SUBJECT: SAN ONOFRE 1 - SEP TOPIC XV-9 STARTUP OF AN INACTIVE LOOP OR
RECIRCULATION LOOP AT AN INCORRECT TEMPERATURE, AND FLOW CONTROLLER
MALFUNCTION CAUSING AN INCREASE IN BWR CORE FLOW RATE.

SUBJECT: SAN ONOFRE 1 - SEP TOPIC XV-9 STARTUP OF AN INACTIVE LOOP OR
RECIRCULATION LOOP AT AN INCORRECT TEMPERATURE, AND FLOW CONTROLLER
MALFUNCTION CAUSING AN INCREASE IN BWR CORE FLOW RATE.

TOPIC XV-9 STARTUP OF AN INACTIVE LOOPIntroduction

Figure 1
 Transient Response for Startup of an Inactive Loop With Full Temperature Decrease

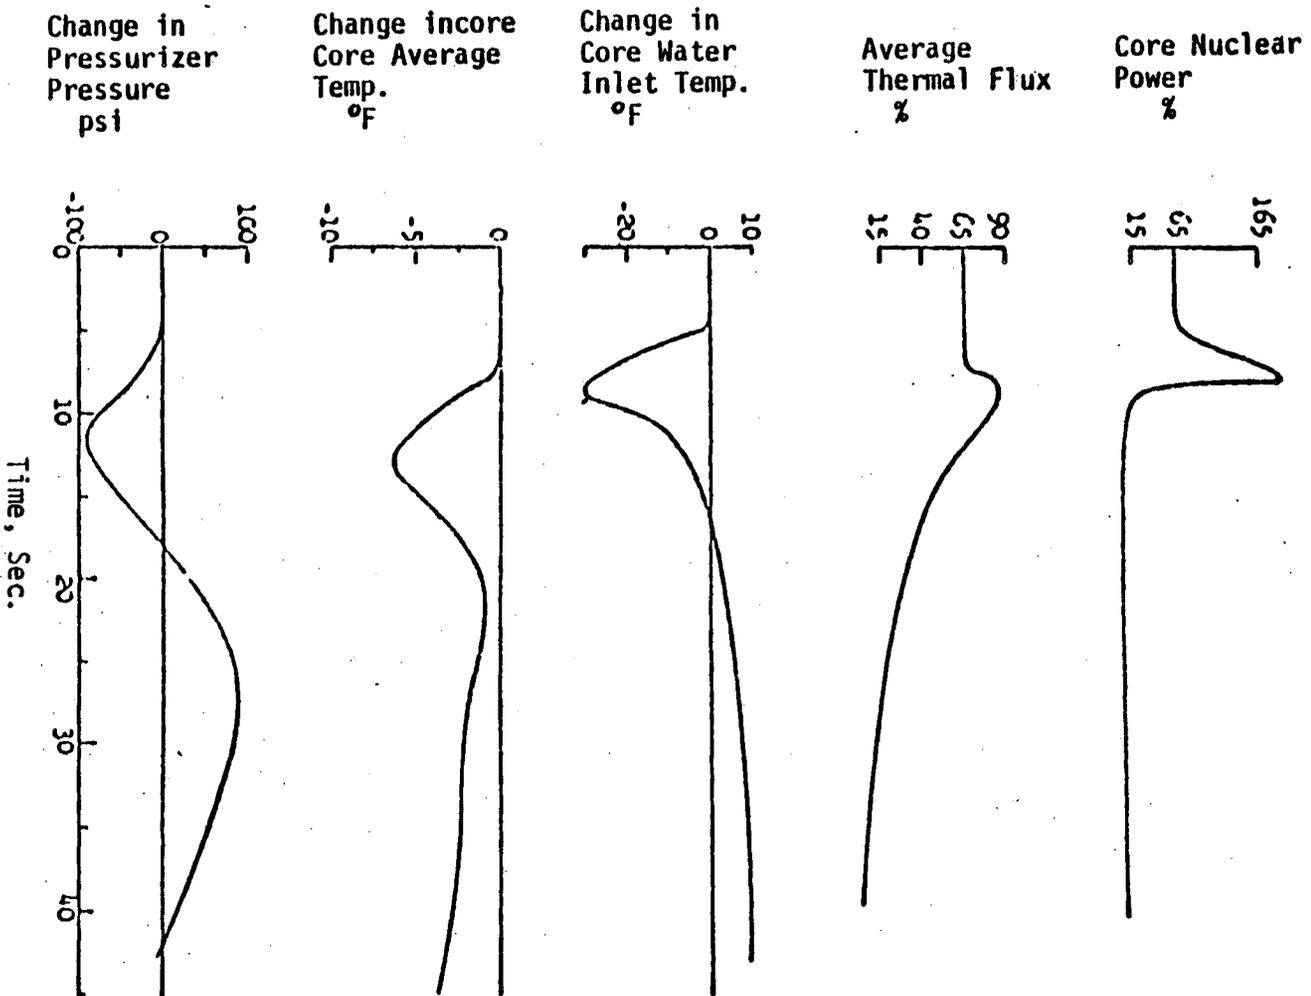
The licensee's results show that a backflow rate of 20,800 gpm in an idle loop was determined for operation with two out of three reactor coolant pumps running. The flow rate through the active loops is 74,500 gpm each, an increase over the normal flow with three loop operation. The resulting total core flow is then 128,200 gpm or about 65 percent of normal three loop flow. The resulting cold leg temperature in all loops is 542°F and the hot leg temperature in the inactive loop is 505°F. The steam generator temperature in the inactive loop is 500°F so the inactive loop is approaching its minimum possible value using the high transfer coefficient. The hot leg temperature in the idle loop cannot go below the steam temperature. The assumed Doppler coefficient is -1×10^{-5} δk per °F and the moderator temperature coefficient is -3.5×10^{-4} δk per °F. The transient results shown in Figure 1 are computed assuming the full 37°F temperature decrease is imposed at the inlet to the reactor vessel. Credit is taken for a mixing delay in the reactor inlet plenum but no credit for flow mixing with the two active loops.

The peak nuclear power drops from 185% in about eight seconds. Thermal flux of about 85 percent is reached. The reactor trip is from overpower at 100 percent. The licensee believes this is a conservatively high value since the overpower trip at this power level would be set to give a maximum trip level of 80 percent of full power.

Since the peak thermal power is less than full power and the inlet temperature is less than the full power value there is margin to DNB. The minimum DNB ratio is 3.1 and occurs at about 10 seconds.

Figure 2
 Transient Response for Startup of an Inactive Loop Without
 Full Temperature Decrease

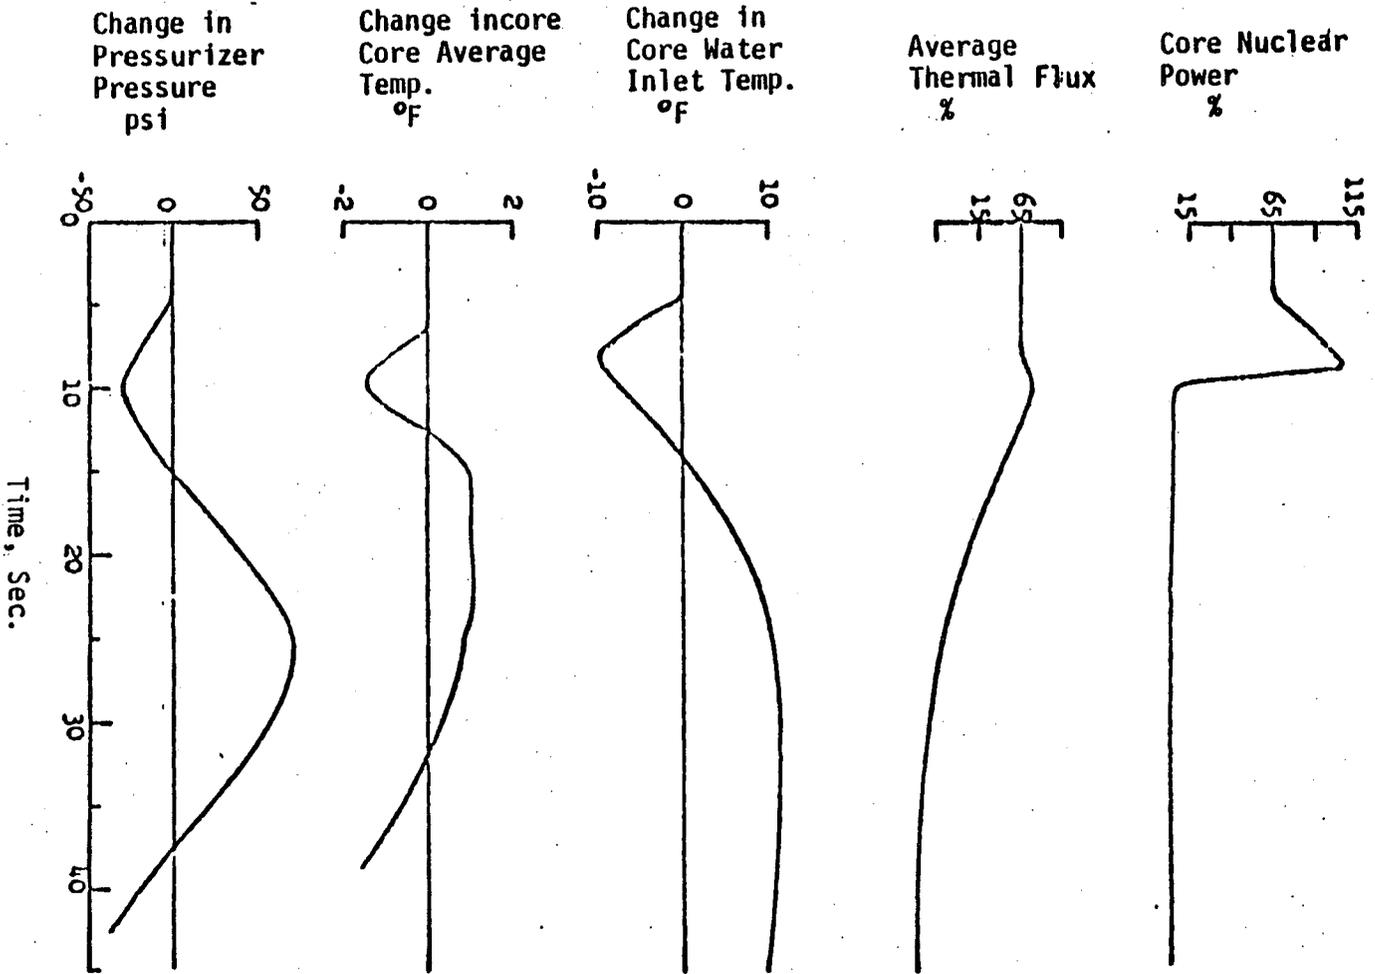
Figure 2 shows the effect of flow mixing with the active loops. The temperature change at the reactor vessel inlet plenum then becomes -12°F instead of -37°F . All other parameters are identical to those for the transients shown in Figure 1. In the case of the reduction of flow mixing with the active loops the pressurizer's pressure peak is significantly reduced. The actual transient would lie somewhere between the two results and would most likely be represented by the results which assume flow mixing. The results also show that the change in pressurizer pressure is less than 100 psia.
